Arm® CoreLink™ CCI-500 Cache Coherent Interconnect

Software Developer Errata Notice

Document version: v5.0

Document ID: SDEN-2287446

Possible deadlock with small Slx_RW_MAX and large TT_DEPTH parameters

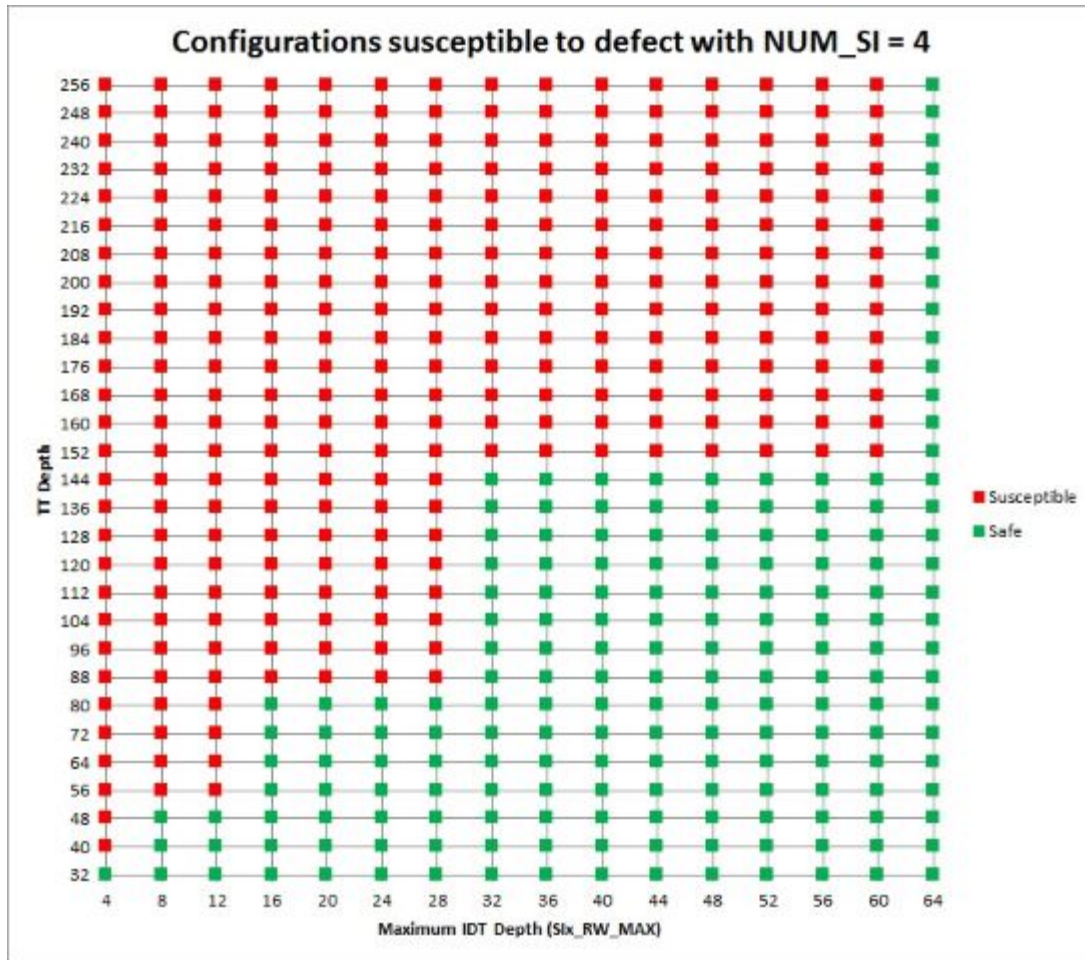
Certain configurations where the maximum ID tracker (IDT) depth is small and transaction tracker (TT) size is relatively large can cause a counter in the request concentrator (cci500_rc.v) to overflow.

Affected combinations of maximum IDT depth and TT size are shown below. The X-axis is the maximum value across all interfaces. For example, if you have interfaces with Slx_RW_MAX parameters of 32, 32, 16, 8 then you use a value of 32 to look up which TT depth values are safe. This example matrix is for 4x slave interfaces but can be provided for other numbers of interfaces on request.

If the counter overflows, tracking of available slots in the TT is impaired which can lead to performance degradation and deadlock.

The only known safe run-time workaround is to disable the snoop filter, using bit[2] of the Control Override Register.

It is better to work around at design-time by choosing IDT and TT sizes that cannot trigger this defect.
